IEC 61924-2
(First edition – 2012)

Maritime navigation and radiocommunication equipment and systems –
Integrated navigation systems –
Part 2: Modular structure for INS –
Operational and performance requirements, methods of testing
and required test results

C O R R I G E N D U M 1

Clause K.2 ACM – Alert command

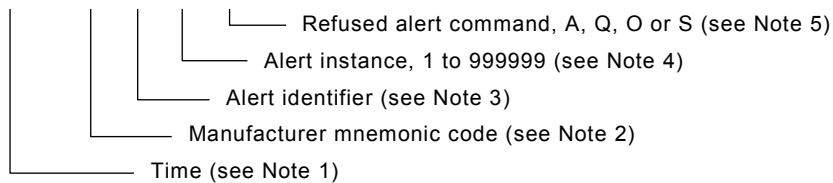
Replace, in the title and the sentence definition (fourth paragraph) ACM by ACN as follows:

K.2 ACN – Alert command

\$--ACN,hhmmss.ss, aaa, x.x, x.x, c, a*hh <CR><LF>

Figure J.1 – Legacy sensor communication showing priority reduction

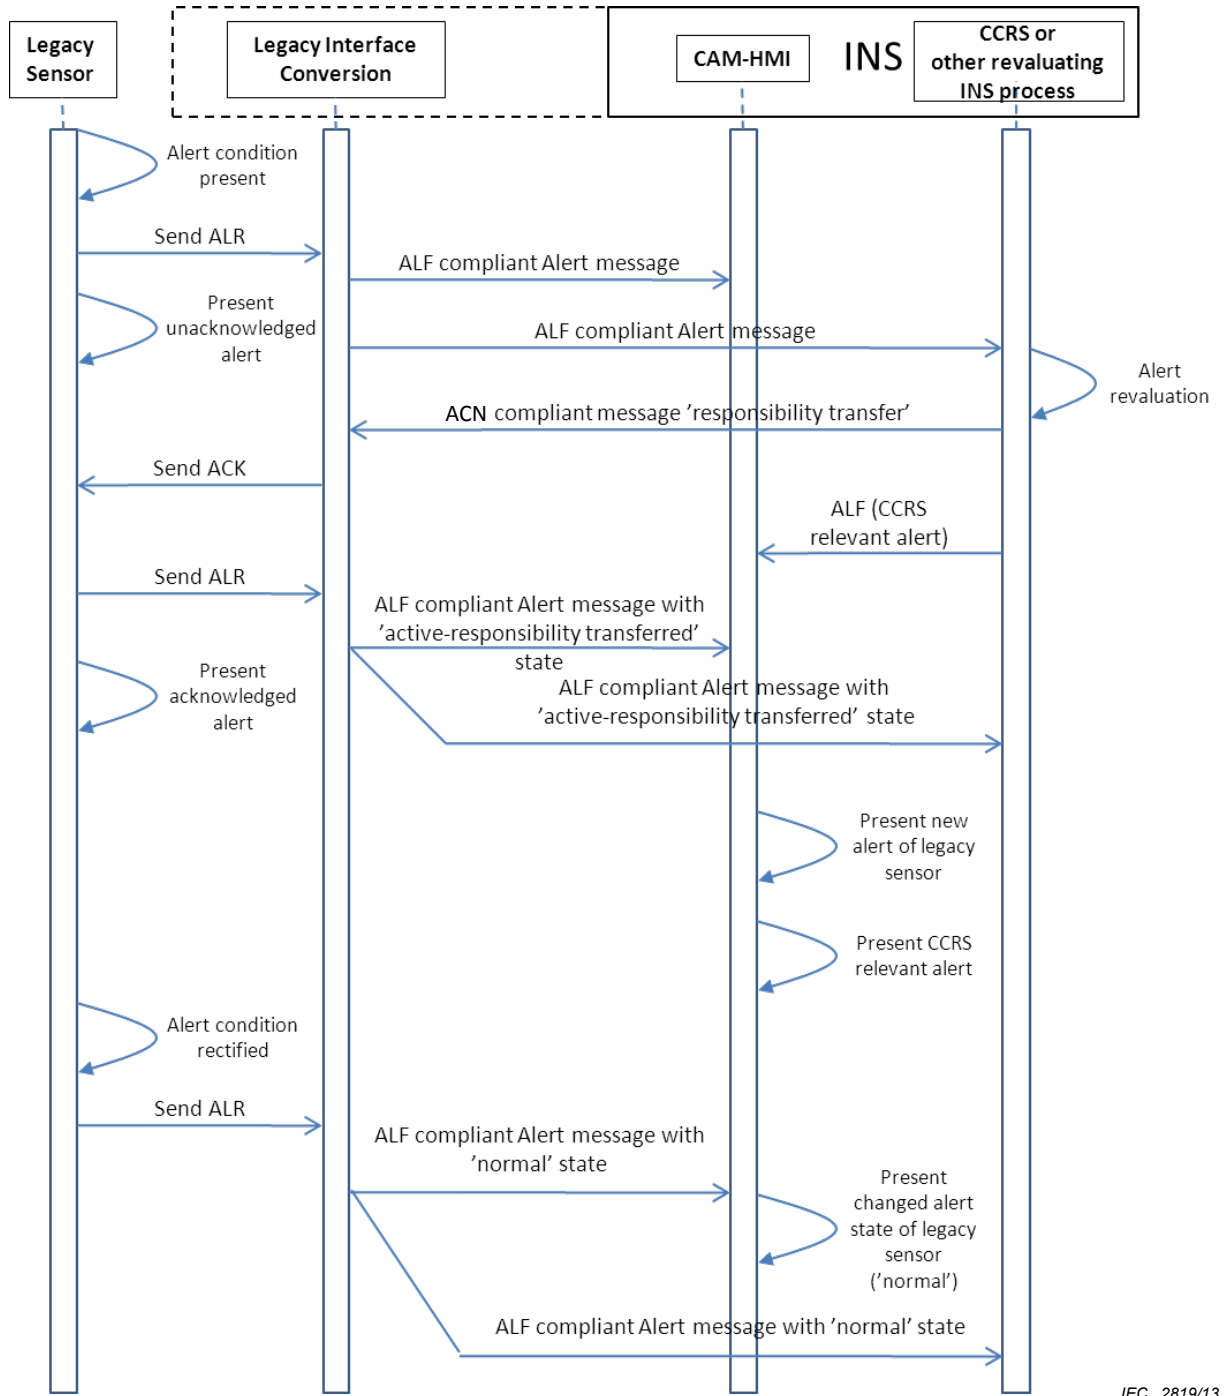
J.3.2	1 st paragraph	
Table J.1	6 th row	
Table J.1	7 th row	
Table J.2	Title	
Table J.2	1 st row, column title	
J.3.2	example below Table J.2	1 occurrence
Figure J.1		1 occurrence, see below
J.3.3	1 st paragraph, below Figure J.1	
J.3.4	1 st paragraph, below Figure J.2	
Clause J.4	Title	
J.4.1	1 st paragraph	2 occurrences
Figure J.3		1 occurrence, see below
Figure J.4		1 occurrence, see below
J.4.6	Title	
J.4.6.1	1 st paragraph	
J.4.6.2	1 st paragraph	
Figure J.5		8 occurrences, see below
Clause K.3	2 nd paragraph	
L.1.1	1 st paragraph
